SERVICE LETTER

No. 707

Subject: Modified Flyball Assembly to Improve RPM Control
-- reference attached Hartzell Service Letter No. 75,
dated November 16, 1973.

SERVICE LETTER NO. 75

A-153(A)-(C) FLYWEIGHT (SEE CHART)
(MATERIAL GROUND FROM
SIDES ON "A" MODIFICATION)

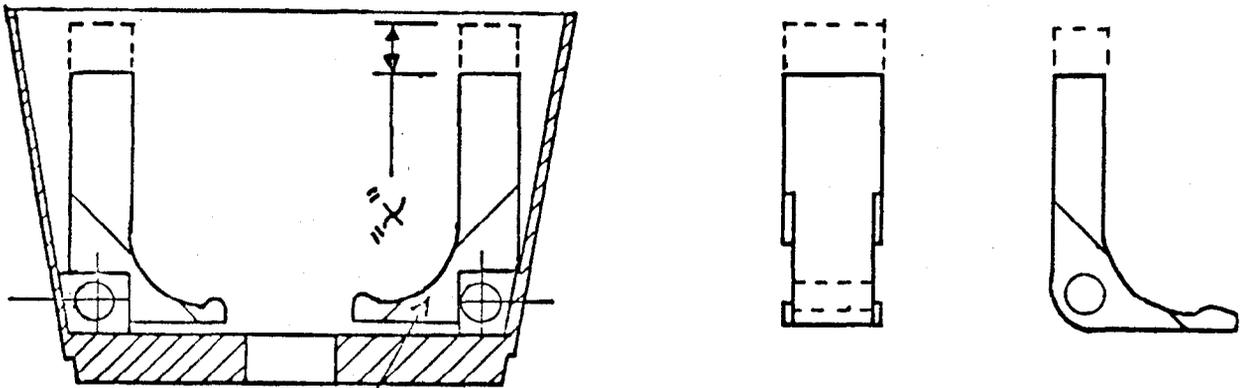
Discussion: To effect an improved RPM control on aircraft with the Hartzell governors, a modified flyweight assembly designed to absorb the torsional motions of the drive gear are being installed in all Hartzell production governors.

- 1) Governors now in the field which are not providing acceptable RPM control may be returned to the factory for exchange. All governors will be brought up to date at overhaul.
- 2) Governors may be modified in the field.

- 1) Determine flyweight assembly needed using parts listed in this letter.
- 2) The flyweight assembly can be changed by:
 - a) removing cover assembly
 - b) removing flyweight assembly locking ring
 - c) removing flyweight assembly
 - d) placing new flyweight assembly in place
 - e) replacing lock ring, making sure it is in place
 - f) replacing cover gasket 50672, and
 - g) installing cover assembly

Apply equal torque to all nuts. If governor is removed from engine, replace governor mounting gasket MS100009.
